Product/Process Change Notice (PCN)

PCN #: WE_RJ45LAN_20150508

Product Affected: WE-RJ45LAN (please refer to table in detail of change stating which part numbers are affected)

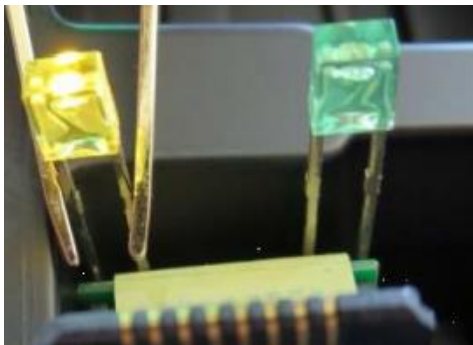
- 4) The new LEDs will have a round form at the LED head, while the head of the old LEDs is flattened. Optical differences for switched on LEDs are small (see wavelengths at pictures below) and have no impact on the general function of the RJ45 connector.

OLD:

Wavelength typ. **568 nm**

NEW:

Wavelength typ. **570 nm**

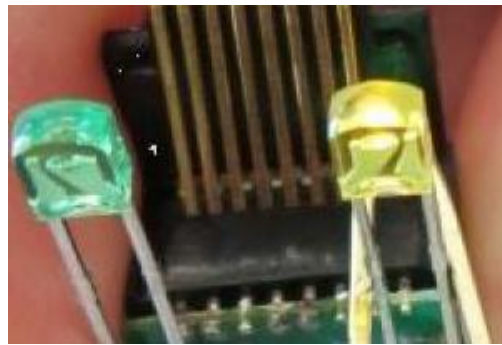
OLD:

Wavelength typ. **588 nm**

NEW:

Wavelength typ. **589 nm**
